MONTGOMERY COUNTY HISTORIC PRESERVATION COMMISSION
STAFF REPORT

Address:	19811 Darnestown Road, Beallsville	Meeting Date:	11/12/2025
Resource:	Darby House Beallsville Historic District	Report Date:	11/5/2025
Applicant:	Montgomery Parks (Timothy Crump, Agent)	Public Notice:	10/29/2025
Review:	HAWP	Tax Credit:	No
Case Number:	1136185	Staff:	Laura DiPasquale
Proposal:	Demolition of accessory structure and construction of new shed.

Figure 5: Site plan showing the existing buildings and proposed shed location.

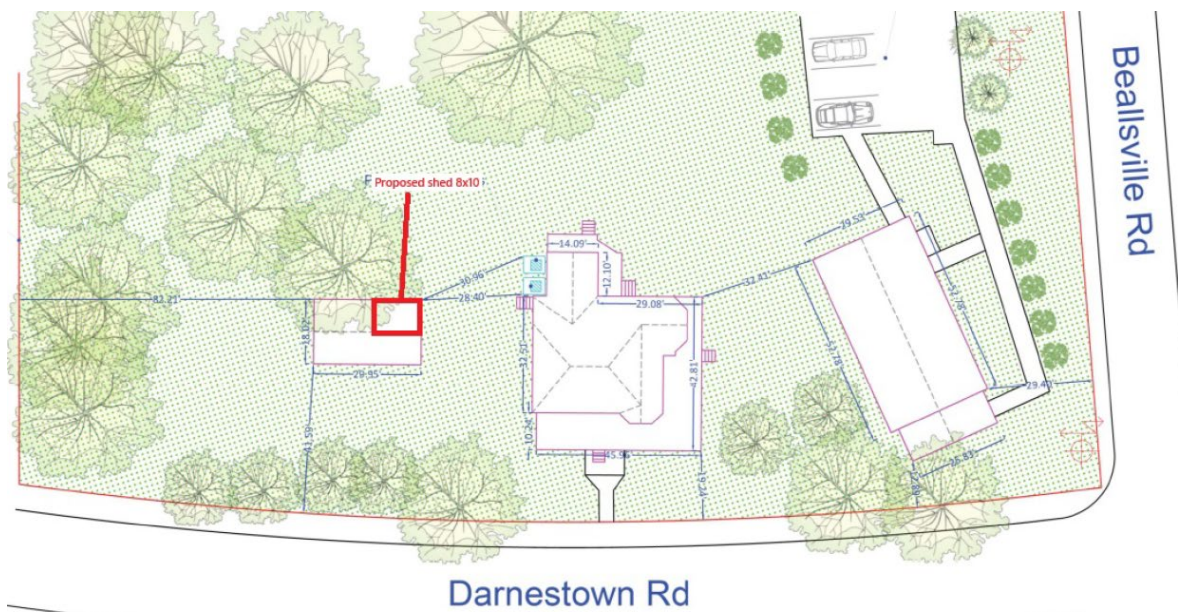
Staff generally finds that the proposed 8-ft x 10-ft shed will not detract from the character of the historic resource, provided it is located in a less conspicuous location on the property than the end of the driveway where it is immediately visible upon entry to the property. Staff finds that, with that condition, the shed will be differentiated from but compatible in character with the historic resource, per *Standard 9* and Chapter 24A-8(b)(2) and will not impair the character of the surrounding historic resources or character of the district, per Chapter 24A-8(d). Staff notes that the application does not specify the corner materials for the shed but that painted wood or painted composite would be more appropriate and compatible with the resource than aluminum corners.

Figure 8: Google Streetview image of the subject property from the driveway with a red arrow showing the location of the proposed shed. Staff recommends that the shed be placed farther from or behind the house, not to be immediately visible from the driveway entrance.

1. The proposed shed must be located in an inconspicuous location on the subject property and not immediately visible from the driveway entrance.
2. The proposed shed must have wood or painted composite corners, not aluminum corners.

Front (south) elevation:

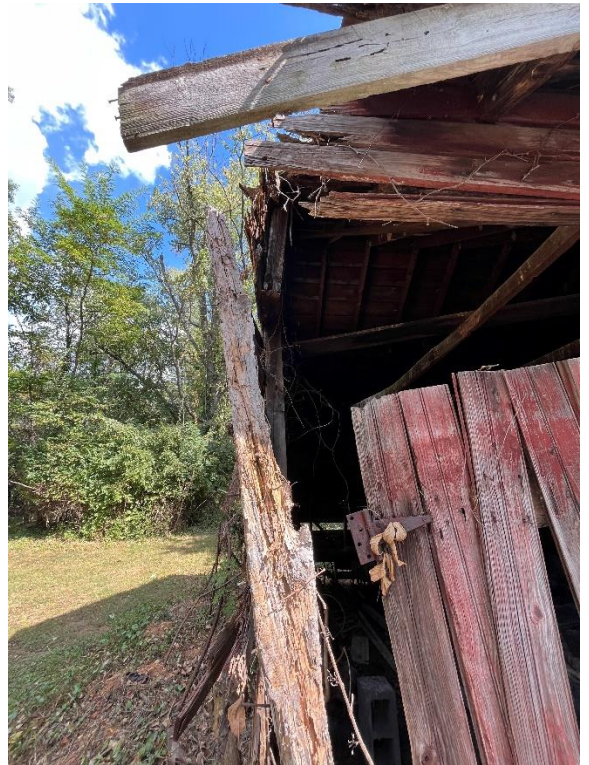
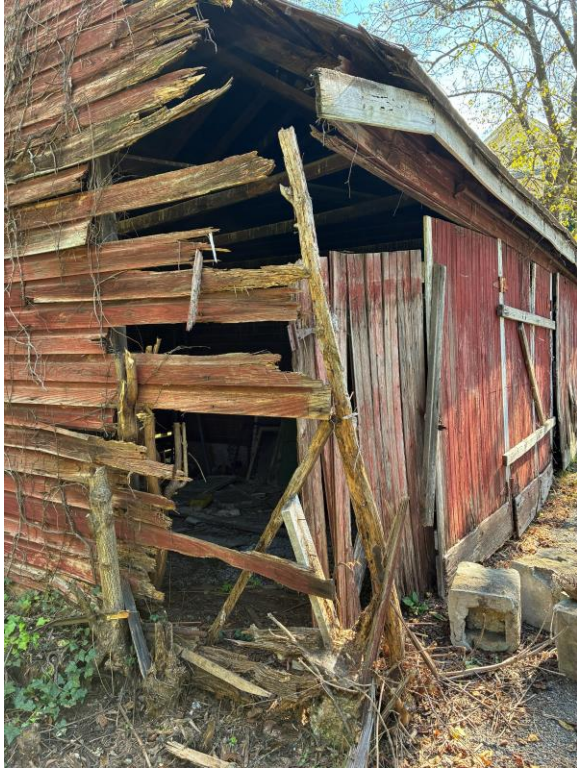
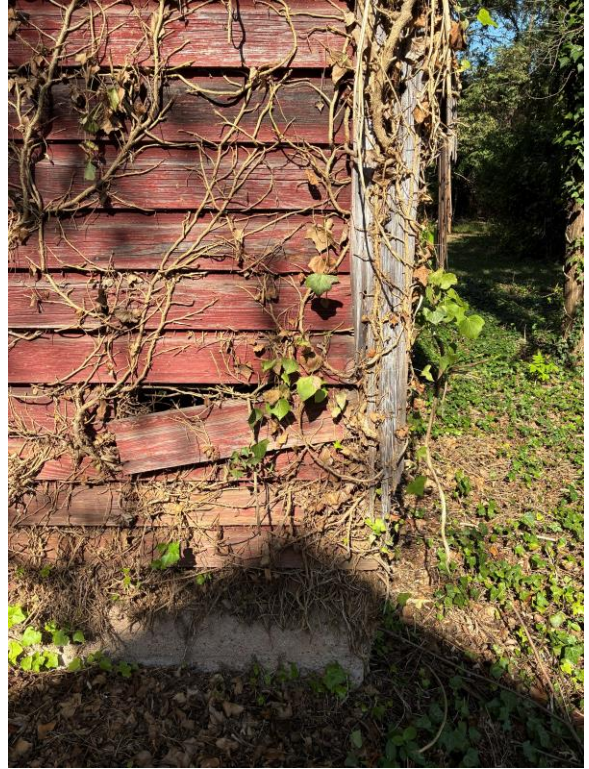
Note deterioration to sliding garage door. Boards are deteriorated; plywood added to rear for stability.

Note structural damage at southwest corner of front elevation: corner post and studs are missing, and roof is unsupported; sill is rotted.

Note missing window in gable;
deteriorated siding, sill and structural
members

Note missing and deteriorated siding, rotten sill
